CNRO-2004-00053

SUBJECT: Early Site Permit - Response to Request for Additional Information Letter
No. 2 (Partial Response No. 1)

ATTACHMENT 1

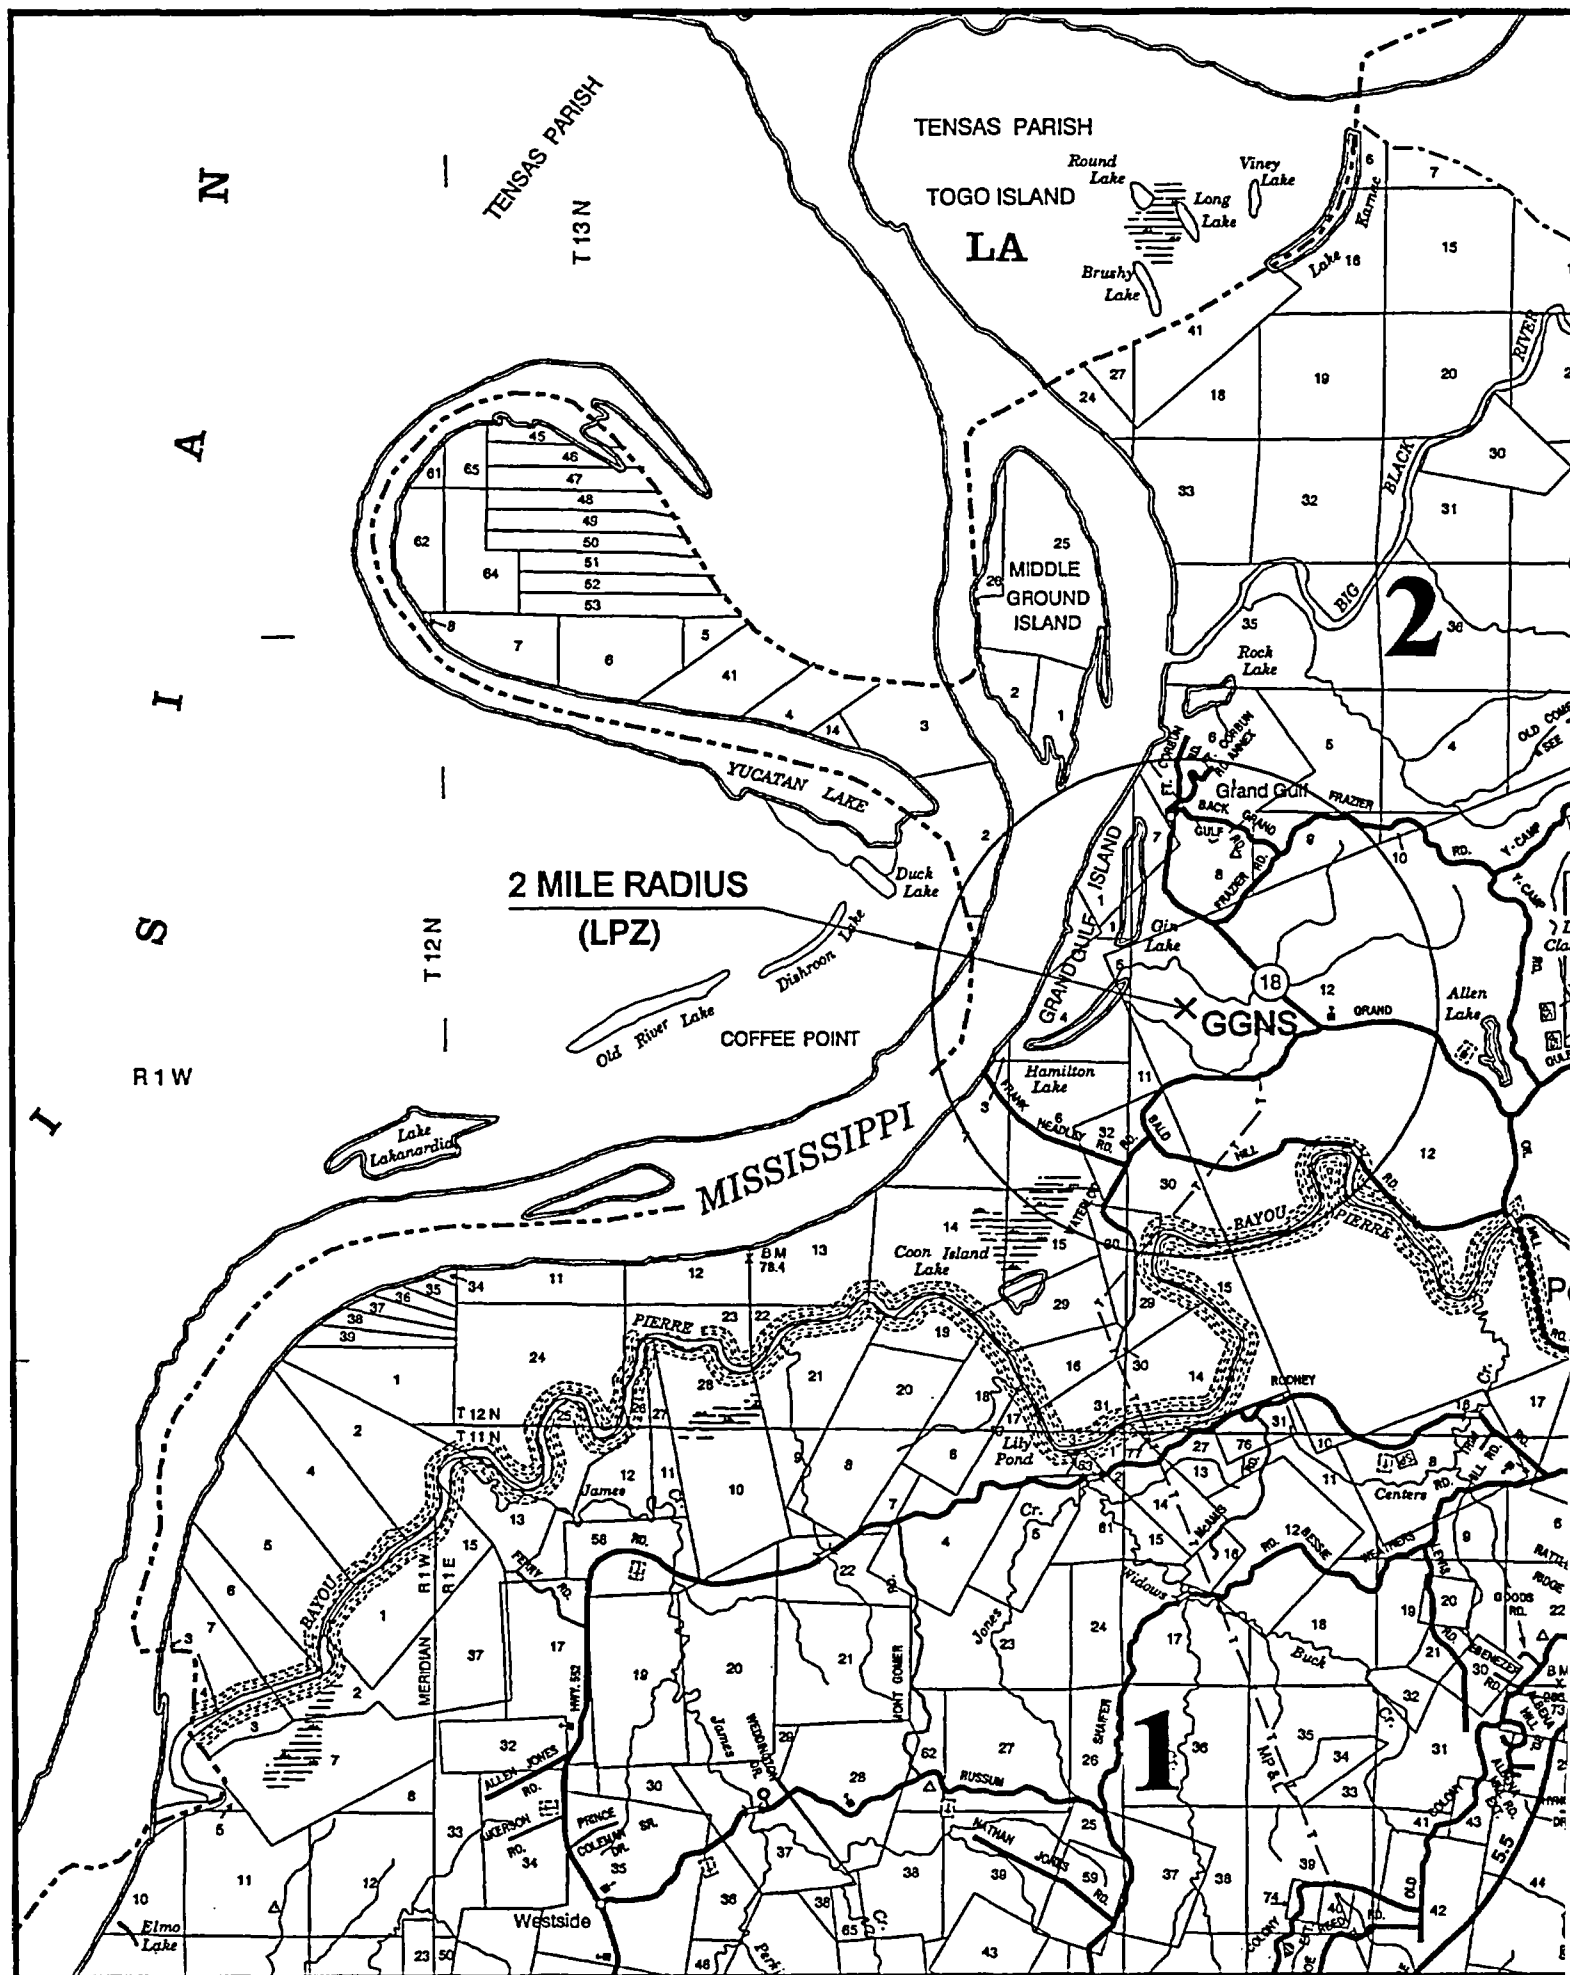
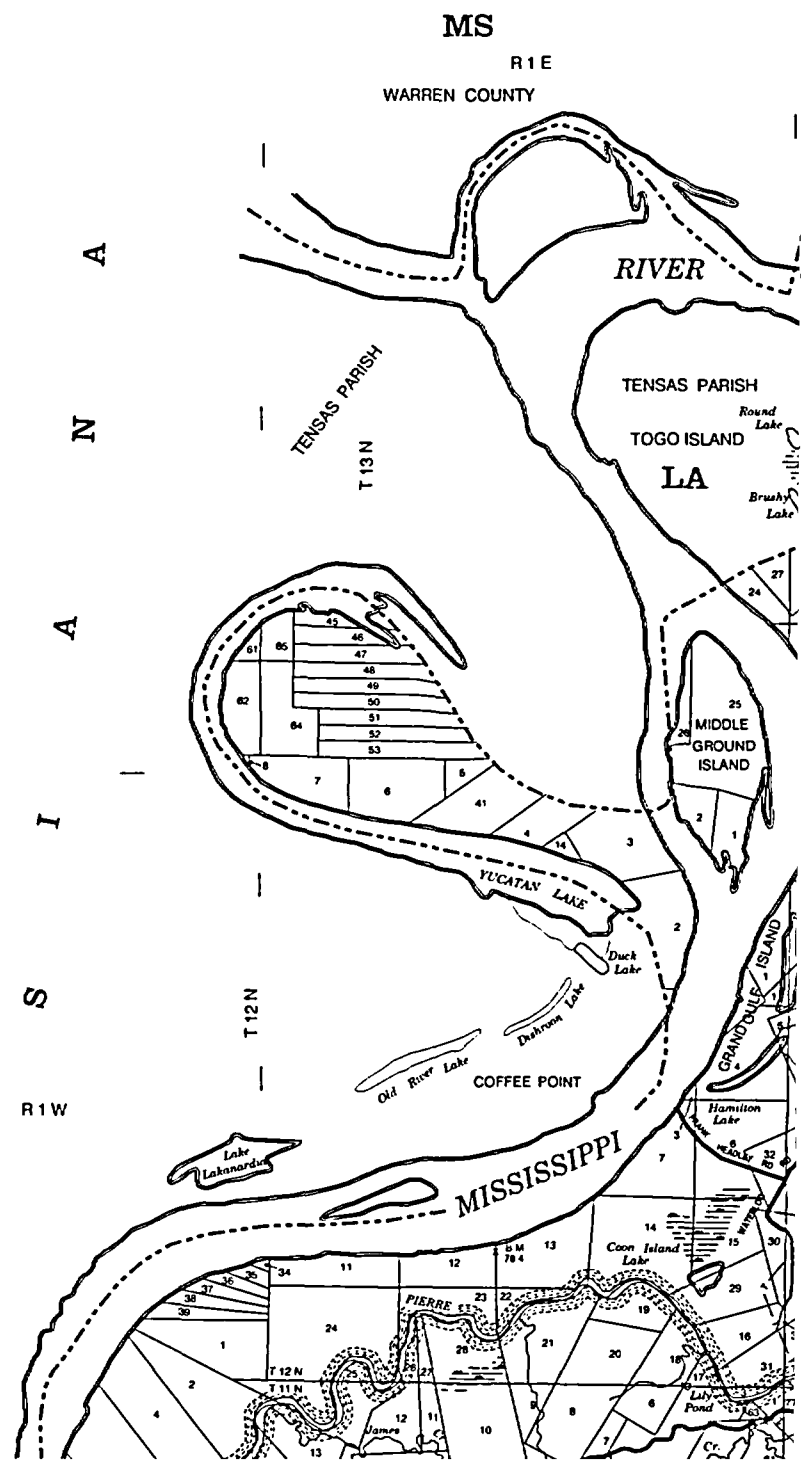
RAI 2.1.3-1

SSAR Figure 2.1-5 illustrates the approximate LPZ, among others. Please provide an expended and legible figure to clearly show the population zone and the distance.

See files: 002_Fig 2.1-5 Draft Rev1.PDF
 003_Figure2.1-5.tif
 004_Figure2.1-5.DWG
